HIGHLY ENRICHED URANIUM WORKING GROUP REPORT

ENVIRONMENTAL, SAFETY AND HEALTH VULNERABILITIES ASSOCIATED WITH THE DEPARTMENT'S STORAGE OF HIGHLY ENRICHED URANIUM

IDAHO NATIONAL ENGINEERING LABORATORY

WORKING GROUP AND SITE ASSESSMENT TEAM REPORTS

INEL CPP-640 (ROVER cells) R tarpaulins cover

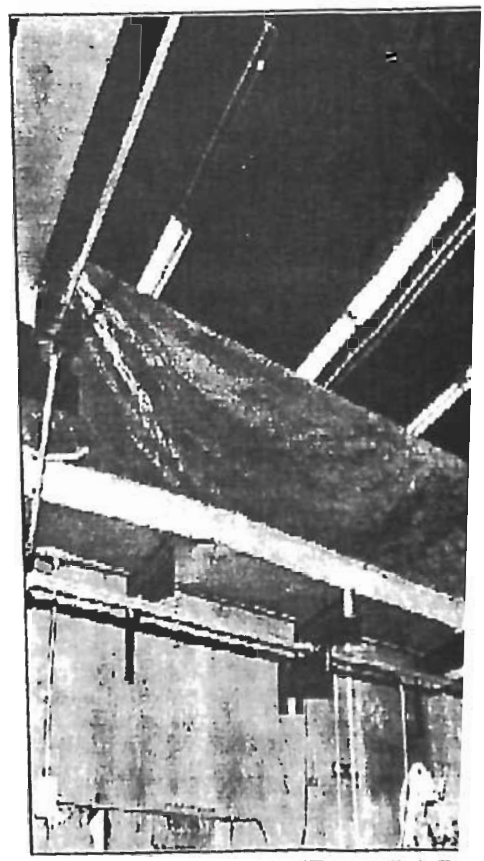
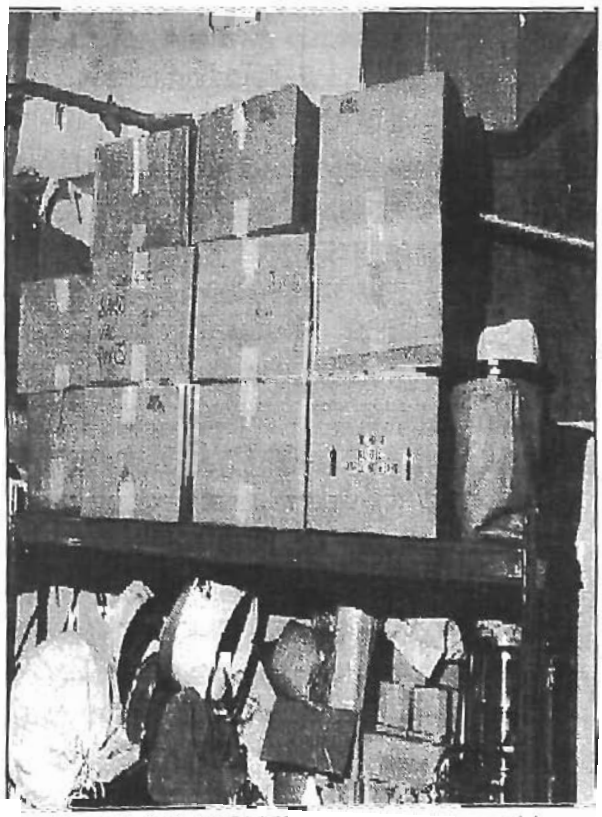
In its walkdown of the ROVER Facility, the WGAT observed the MHC and process cells. During ROVER Facility operation, the MHC was used to feed the ROVER fuel to the burners located in cells 3 and 4, and the resulting ash was transferred to cell 2 where it was dissolved in nitric and hydrofluric acids. Cell 2 has since been washed and now contains only trace quanti HEU. Several of the equipment units MHC [illegible]lding, and tem contamination boundary control composed of metal supports with covering have recently been erecte plastic glovebox, to aid in the rem process equipment and supplies, is construction. Wood is being used for and support in this glovebox. The e approximately 10 years without opera evident in the dust and trash accumu the facility.

The WGAT noted a potential for lea roof over the top hatches of the hot to the age and degradation of roo Water leakage through these hatch cause a loss of moderator control

RWMC – ASB-II

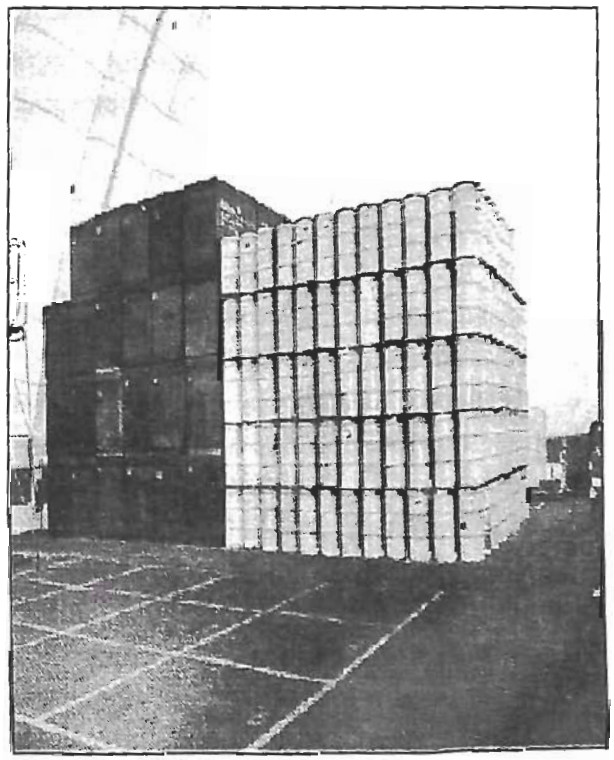
In addition to SAT vulnerabilities, the WGAT identified two vulnerabilities (WGAT 03 and 04) related to worker exposure from waste handling and storage operations. Within the ASB-II facility, the WGAT identified numerous corroded drums containing U-233 among the

stacked TRU waste containers. Given the height of the stacked drums (five high) and the lack of restraints, the WGAT was concerned that a drum could fall and rupture, exposing a worker to the contents. This event could be initiated by a forklift accident, a drum mishandling, or an earthquake. While the SAR addressed this condition, a breach of primary barriers is based on an average container loading of TRU waste and does not take into account the presence of U-233/232 materials. This was cited by the WGAT as vulnerability WGAT/03.

The INEL staff recognizes the potential of the events described in this VAF. A structural a been performed of the stack array and the consequences of a drum rupture and worker cont have been evaluated. The drums are planned for shipment to WIPP by 2003, pending resol WIPP facility startup.
